**CN Milton Logistics Hub – Project Changes
Report (Multiple Changes)**

File: 160901330

This report has been prepared to describe a series of proposed changes resulting from refinements made during the detailed design of the proposed terminal components. Section 2.0 provides a description of the proposed Project changes, including:

**Proposed Project
Change Locations**

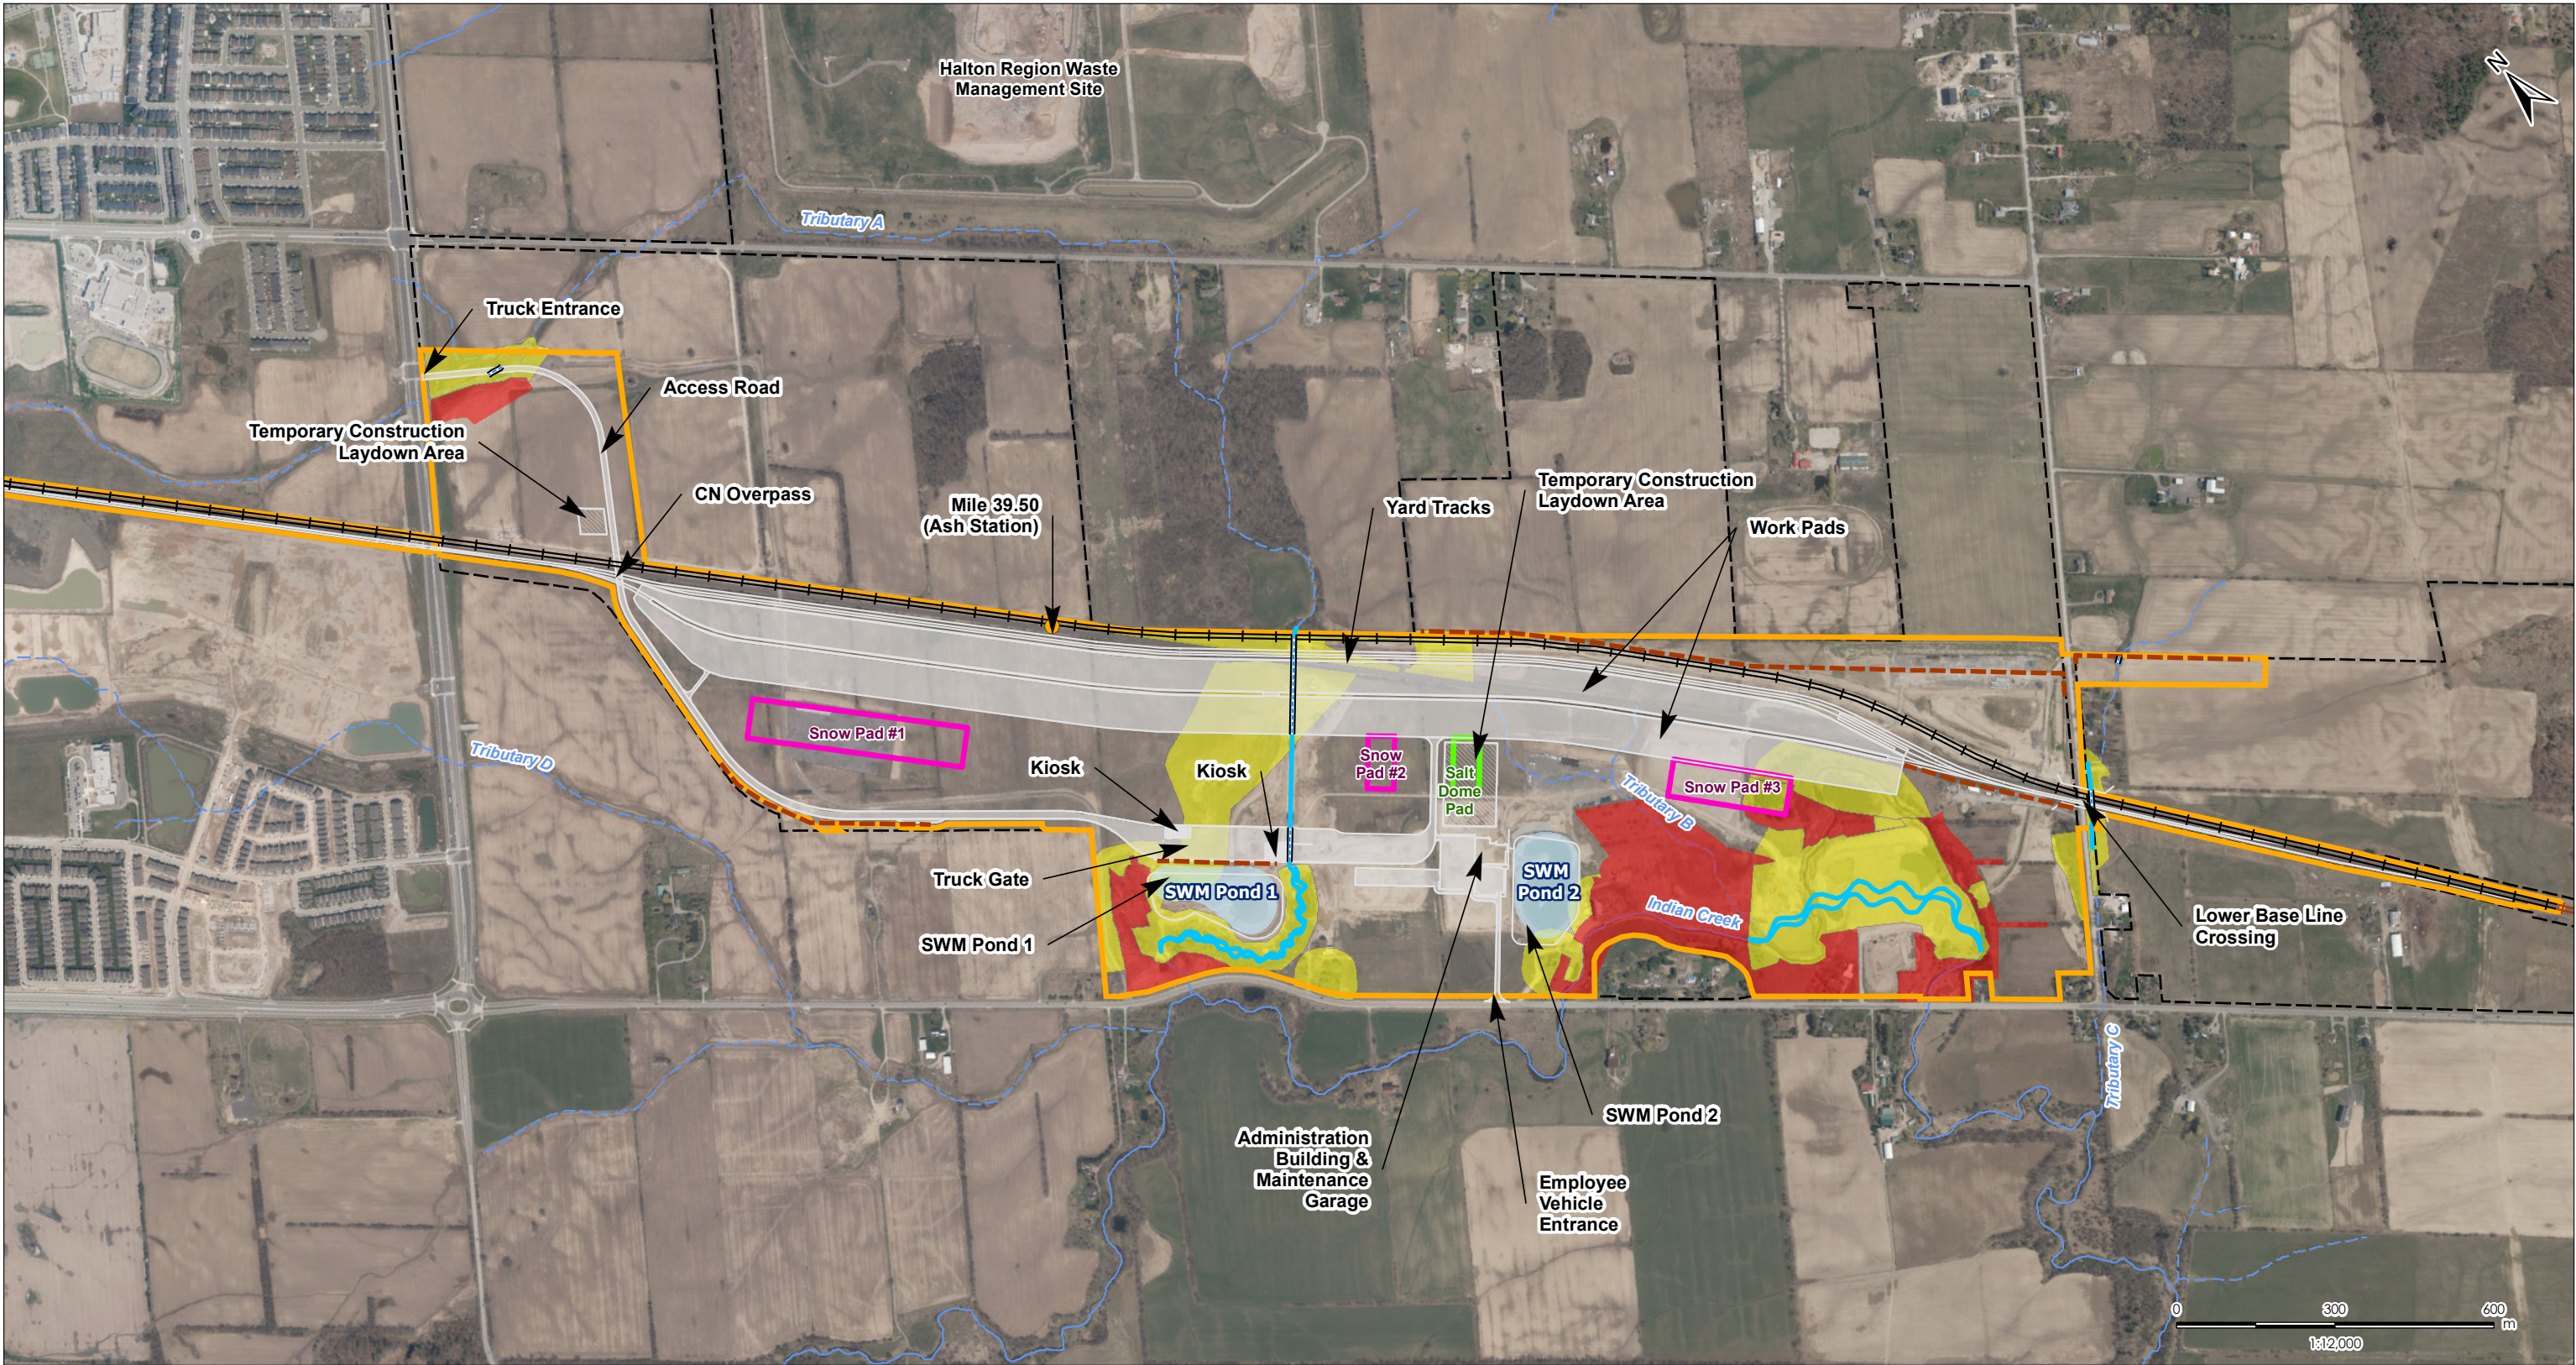
The general locations of the above Project changes are identified on Figure 1 in Appendix A.

- Snow Storage Pad #1: Approximately 3.1 hectares, located on the west side of the Terminal, south of the work pads, and northeast of the proposed noise berm along the access road from Britannia Road.
- Snow Storage Pad #2: Approximately 0.5 hectares, located south of the work pads and west of the proposed access road and temporary construction laydown area.
- Snow Storage Pad #3: Approximately 1.58 hectares, located south of the work pads on the east side of the Terminal.

Each pad area would be surrounded by ditches designed to collect and convey meltwater and runoff to either Stormwater Management (SWM) Pond 1 or 2. The general locations of the proposed snow storage pads are shown on Figure 1 in Appendix A, with additional details provided in Appendix C.

The location of the proposed salt storage facility is shown in Figure 1 in Appendix A, and illustrated on the engineering drawings in Appendix C.
